26<sup>th</sup> October 2006

**Submission to: Draft Rule Determination –  
Management of Negative Settlement Residues by Re-orientation**

Diagram 1

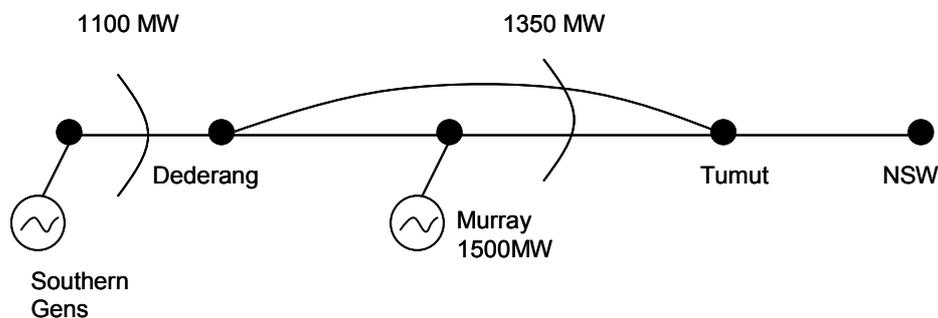
From Diagram 1, it can be seen that Murray is the only generator that can supply 250MW through the Murray to Tumut cut-set (ie. 1350MW – 1100MW). If only a CSP is implemented for Murray generation (as per the SGen’s proposal) Murray faces the profit curve as shown in diagram 2 (with the assumption that the flow from Vic to Snowy is at the maximum 1100MW).

Diagram 2

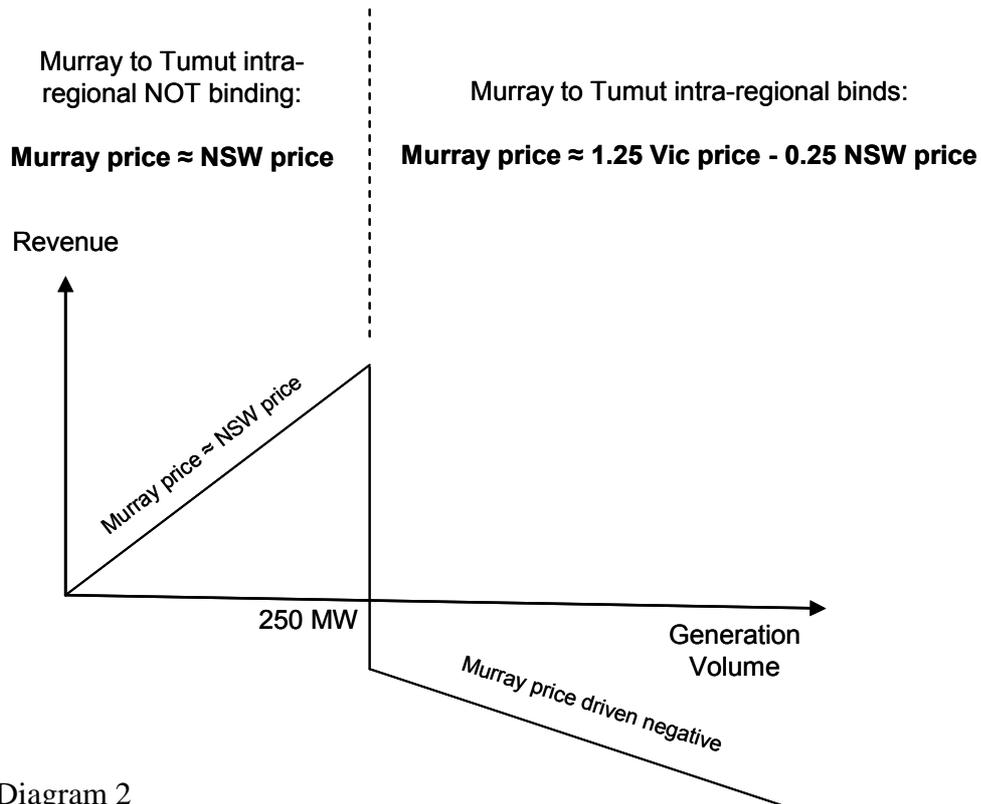
The profit curve shown in diagram 2 places strong commercial incentives on Murray generation not to generate above 250MW and constrain the intra-regional constraint between Murray and Tumut. In effect, 1250 MW of available Murray generation is effectively withdrawn from competition in the Victorian market. This is clearly inefficient as it removes available generation and reduces competition.

Diagram 3

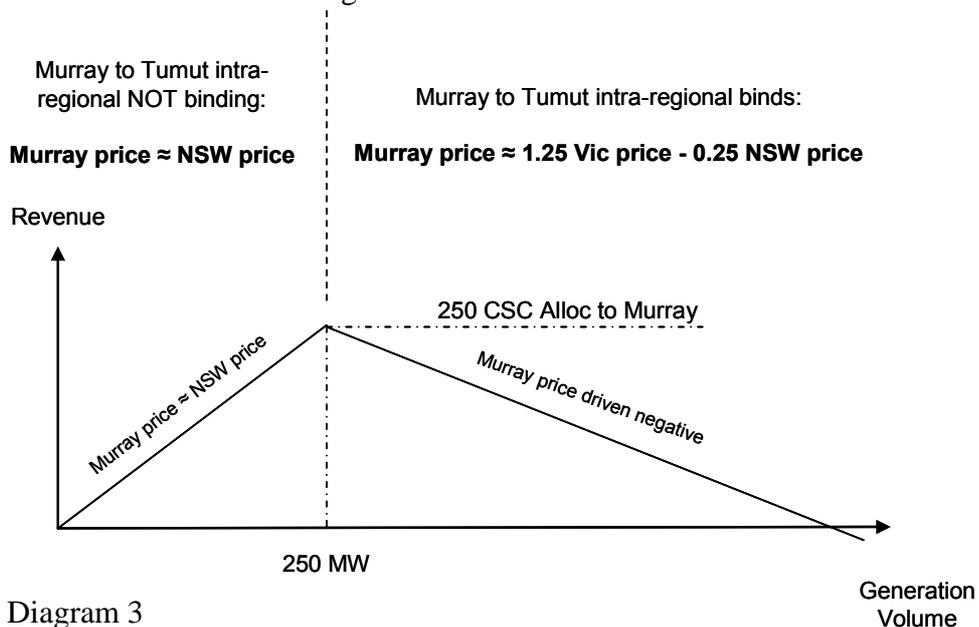
A complete CSP/CSC scheme would allocate Murray 250MW CSC to access the NSW region (NSW load) as this amount represents Murray generation's uncontested transmission access to the NSW Region. This CSC allocation would provide Murray with profit curve as shown on diagram 3.

Clearly, the profit curve in diagram 3 offers much better incentives for Murray generation to be available and provide competition in Victoria. Hence this is a more efficient arrangement while still recognising Victorian generators have better constraint coefficients.

Diagram 4

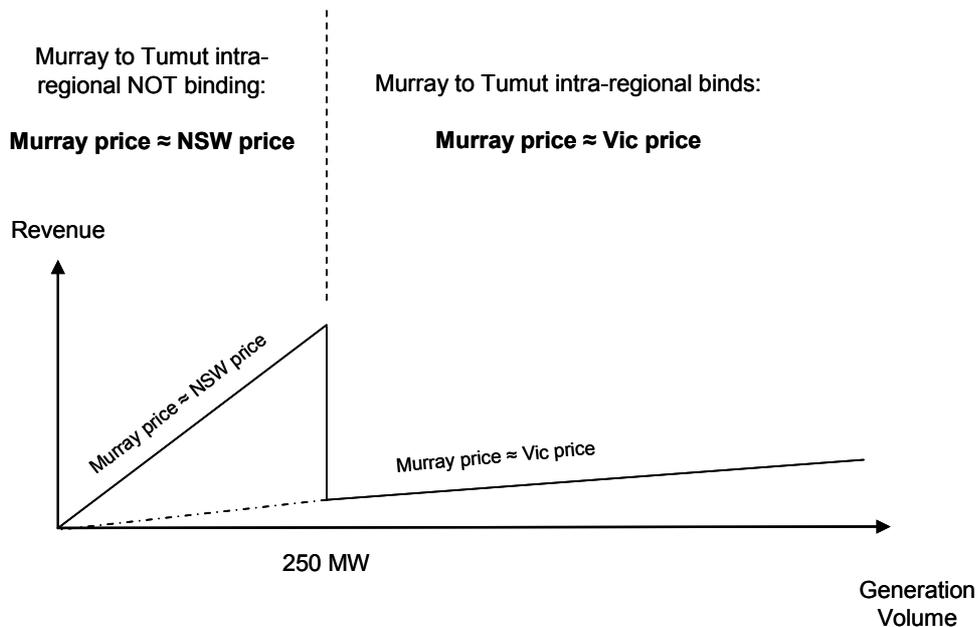
Snowy Hydro believes the re-orientation proposal and the CSP/CSC (with CSC allocation to Murray) in fact offer very similar incentives on Murray generation. The re-orientation profit curve for Murray is shown on diagram 4 (assuming the Vic to Snowy interconnector flow is 1100MW).

Diagram 5

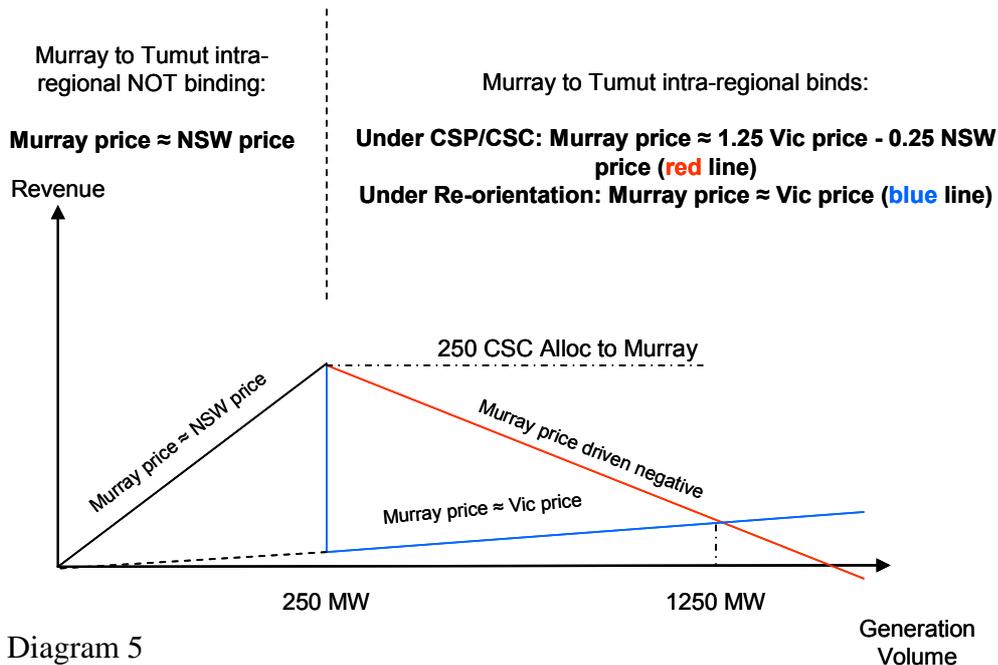
When comparing the CSP/CSC and the re-orientation arrangements, it can be shown that the generation level at which the profit curves of the two arrangements intersect is 1250MW (see Appendix 2 for details of this calculation). The intersection of the CSP/CSC and re-orientation proposals is shown diagram 5.

In comparing the CSP/CSC arrangement with the re-orientation arrangement, from diagram 5 both proposals are the same if Murray generates at 1250MW. Under re-orientation Murray is slightly worse off if Murray generates between 250 and 1250MW and under re-orientation Murray is better off if generates above 1250MW.

Diagram 5

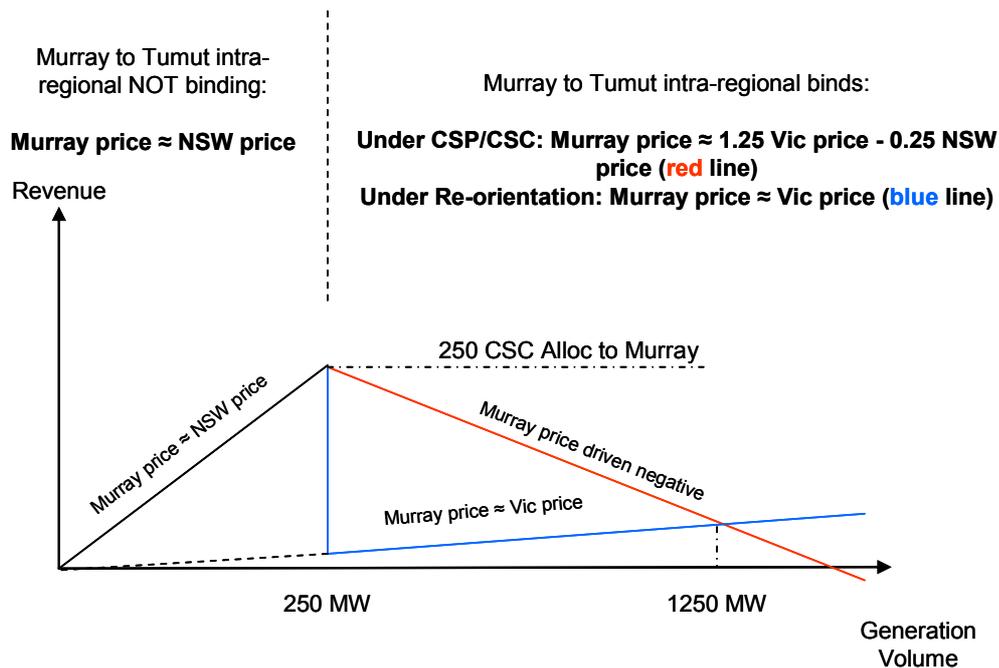
The figure of 1250MW was calculated in the following manner:

$$\begin{aligned} \text{CSP/CSC profit} &= \text{Re-orientation profit} \\ \text{CSC} * \text{NSW} - \text{Murray} * (\text{X} - \text{CSC}) &= \text{X} * \text{Vic} \end{aligned}$$

$$250 * \text{NSW} - 0 = \text{X} * \text{Vic} \quad \text{Equation 1.}$$

$$\text{Vic} = 0.8 * \text{Snowy} + 0.2 * \text{NSW}$$

$$250 * 5 * Vic = X * Vic$$

Therefore  $X = 1250MW$
